Department of Energy; Yucca Mountain, Nye County, Nevada; Supplemental Environmental Impact Statement

Document: NRC-2015-0051-DRAFT-0050

Attached my comments Specifically document NUREG-2184

Comments to Groundwater Comments Supplemental Environmental Impact Statement Aug. 21, 2015.

Furthermore, the NRC adopted a 2009 COE publication entitled "Analysis Post closer Groundwater Impact (2009). Upon reviewing the NRC document of 2009 Vol 3 which contain a major scientific errors as shone in **Figure 1. Illustrates Daily intakes of**

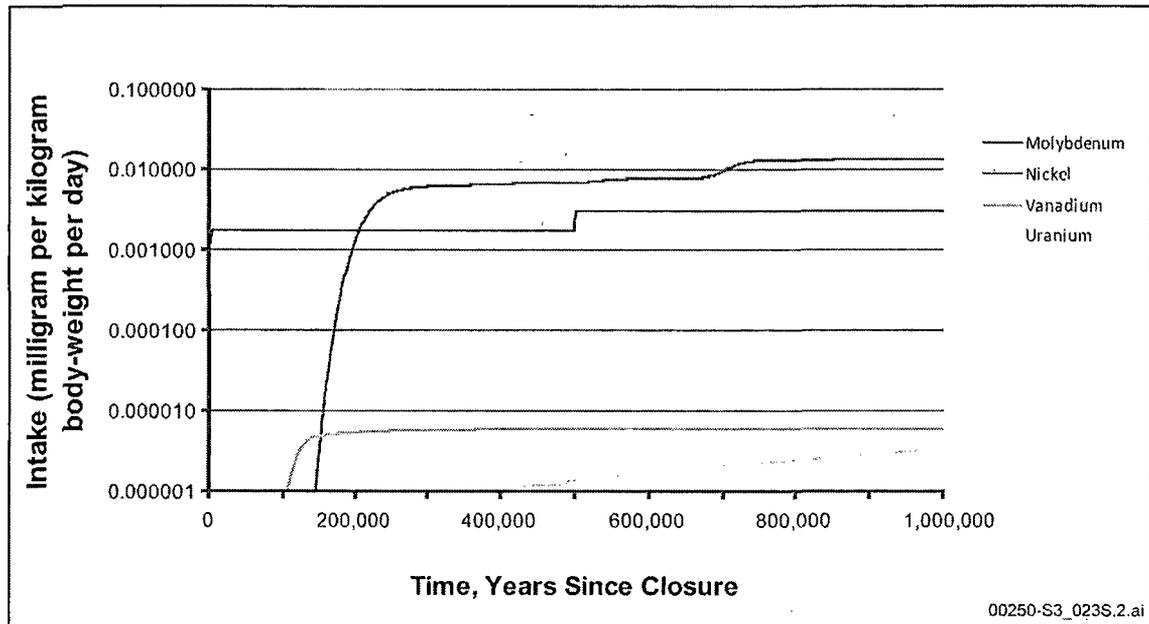
- **Why Cr, a potent carcinogen, and V excluded were excluded from daily intake?**
- Since, about 43,300 tons of chromium will be deposited at YMP Site (EIS 2002) in addition to the 70,000 tons of radionuclides what credible scientific explanation the DOE and the NRC can provide a scientific Justification since no data were provided for the near zone.

- Next, it is unclear if the sorption of zeolite followed the proper scientific order where light elements replaced heavy elements. This is **incorrect Mo>V>Ni>U** as showed in Figure 1.
